Access Compliance Report

Public Rights-of-Way

(Curb Ramps)

Intersection ID: 51370	Main Street: UNIVERSITY_POINTE_BV	Cross Street: IKEA_BV	Location: W
ADA ID: D6E790C421C5	Ramp Type: Perp	Initial Pass/Fail: Fail	Overall Compliance: No Severity Score: 13.75

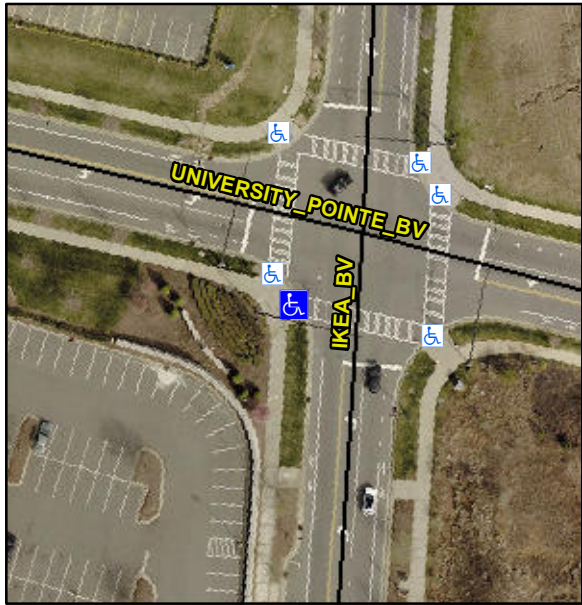
Codes/Mitigation Info/Possible Solution			Field Measurements/Component Compliance					
	Possible Solutions:		Compliance	Description	Data	Compliance	Description	Data
	Remove & Replace Entire Ramp.		N/A	Ramp Length (in)	128.0	No	Ramp Slope (%)	8.7
			Yes	Ramp Width (in)	56.0	Yes	Ramp XSlope (%)	2.6
			N/A	Flare Type LT	N/A	N/A	Flare Type RT	N/A
			N/A	Flare Slope LT (%)	N/A	N/A	Flare Slope RT (%)	N/A
			N/A	Flare Traversable LT?	N/A	N/A	Flare Traversable RT?	N/A
			N/A	Landing Length (in)	N/A	N/A	DWS Provided?	N/A
			N/A	Landing Width (in)	N/A	N/A	DWS Contrast?	N/A
			N/A	Landing Slope (%)	N/A	N/A	DWS Length (in)	N/A
			N/A	Landing X Slope (%)	N/A	N/A	DWS Full Width?	N/A
Surveyor Notes:	N/A		N/A	Landing Curb? (Y/N)	N/A	N/A	DWS Offset (in)	N/A
			N/A	Shared Landing?	N/A			
			N/A	Gutter Ponding?	N/A	N/A	Gutter Slope (%)	N/A
			N/A	Gutter Lip Ht (in)	0.5	N/A	Gutter X Slope (%)	N/A
			N/A	Painted X Walk1?	Yes	N/A	Painted X Walk2?	N/A

X Walk 1 Direction	To SE		X Walk 2 Direction	N/A
			N/A	X Walk 1 Width (in)	113.0	N/A	X Walk 2 Width (in)	N/A
				X Walk 1 Slope (%)	4.7		X Walk 2 Slope (%)	N/A
				X Walk 1 X Slope (%)	4.5		X Walk 2 X Slope (%)	N/A
			N/A	Ramp inside XWalk1?	Yes	N/A	Ramp inside XWalk2?	N/A
PROW/ADA:	Not Found, R304.2.2			Road Slope (%)	N/A	N/A	Clear Space?	N/A
				Road X Slope (%)	N/A	N/A	Clear Space to XWalk (in)	N/A
			N/A	Any Obstructions?	N/A	N/A	Storm Grate/Utility Hazard?	N/A
				Obstruction Type			Storm Grate/Utility Type	
					N/A			N/A
						Yes	Surface Condition? (G/P)	Good
Total Cost:		\$ 1850.00
